### CORRIGENDUM-III

#### RFP ENQ. No.- OCAC-NEGP-INFRA-0007-2021-22061 Dated 23.08.2022, for Selection of Agency for Implementation, Operations and Maintenance of OSWAN NOC

### **6.3. OSWAN-NOC Layout:**

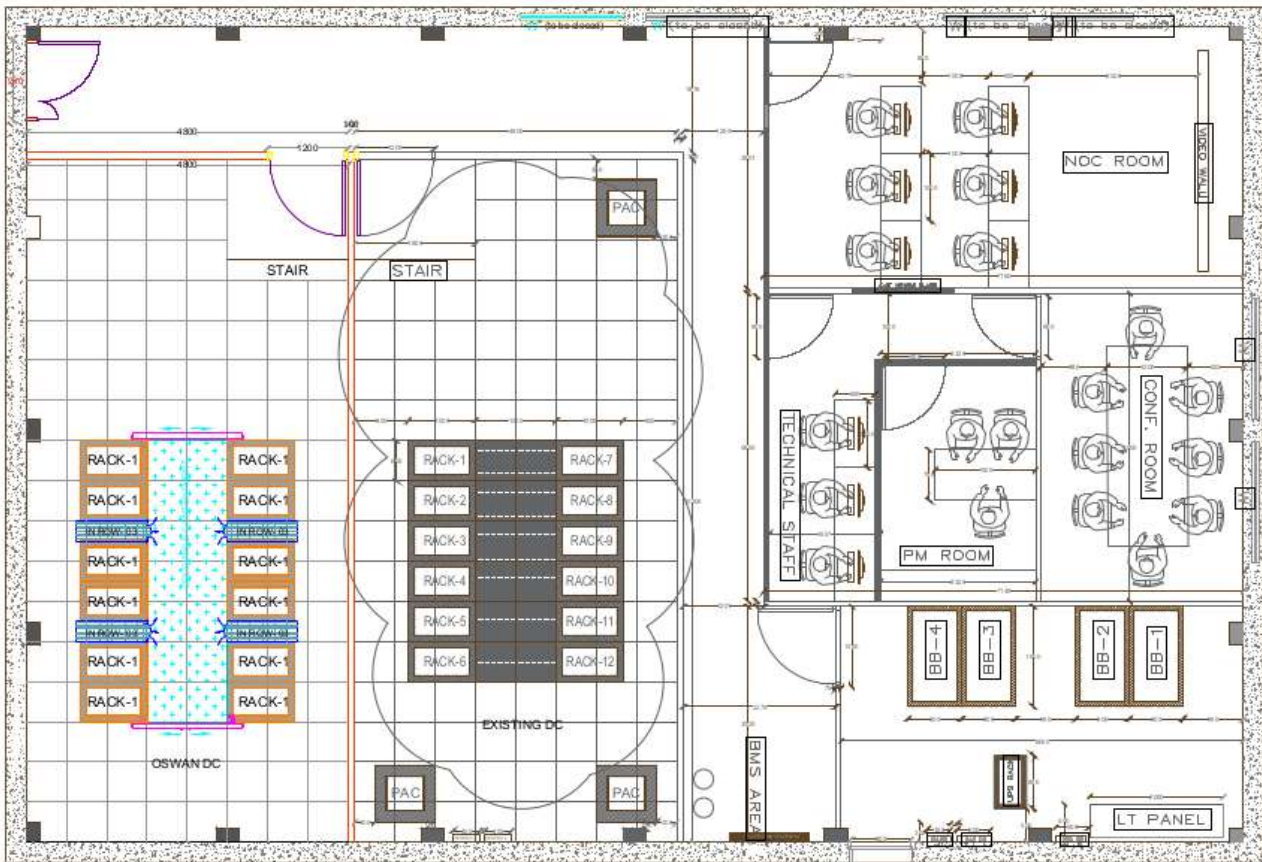
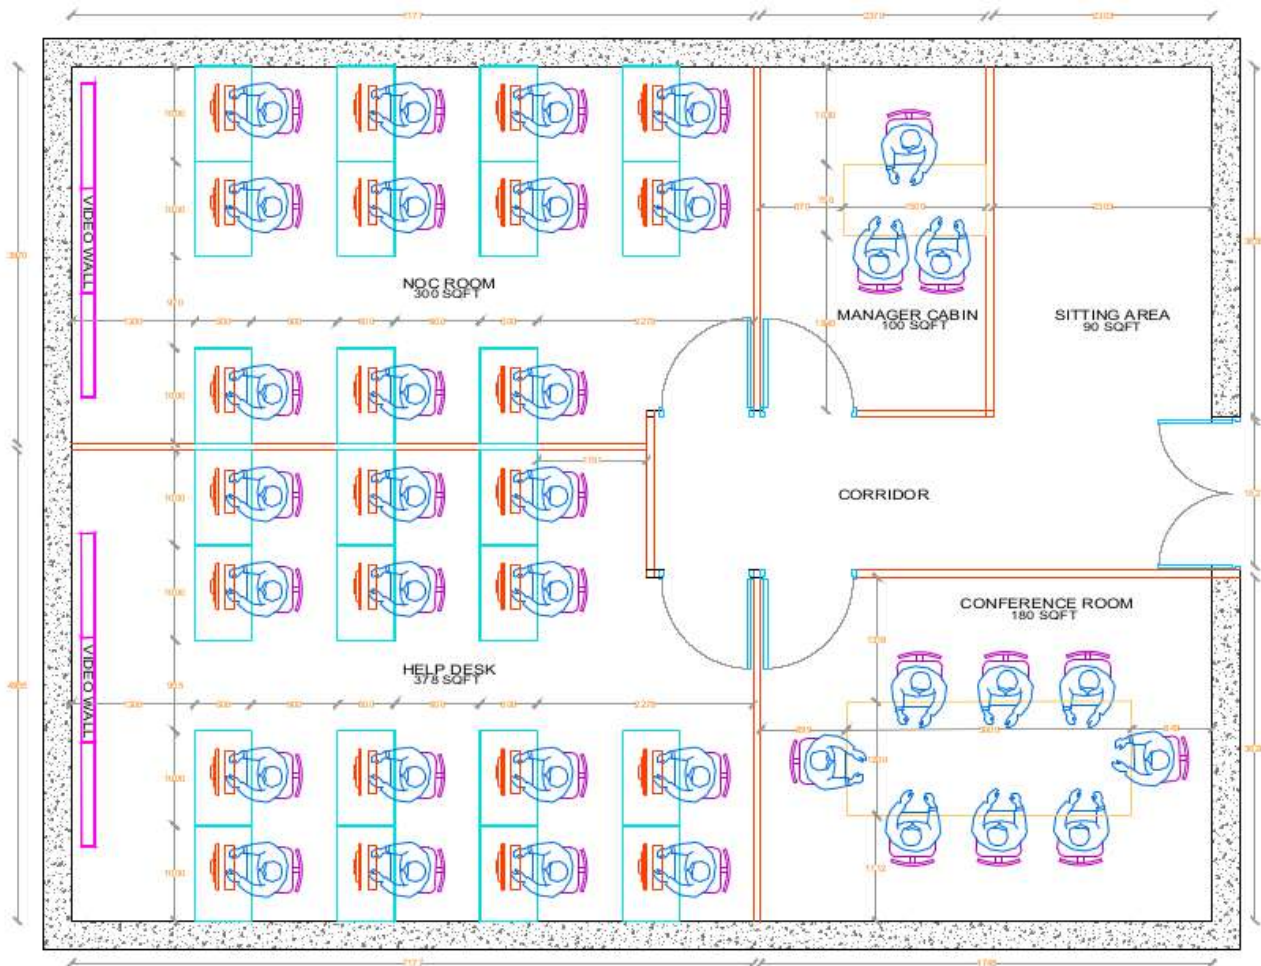
Sr. No.	Page No	Clause No	RFP Clause	Query /Clarification/ Suggestion if any asked		Modification/ Addendum/ Deletion/ Clarification
107.	36,37		The diagrams and layout are on the page 36 and 37	Is OSWAN NOC Room, Office Area Layout and OSWAN Helpdesk Room is final as per the OSWAN RFP doc ?		<b>Clarification:</b> It may change as per the space availability and as best practice of bidder solution.
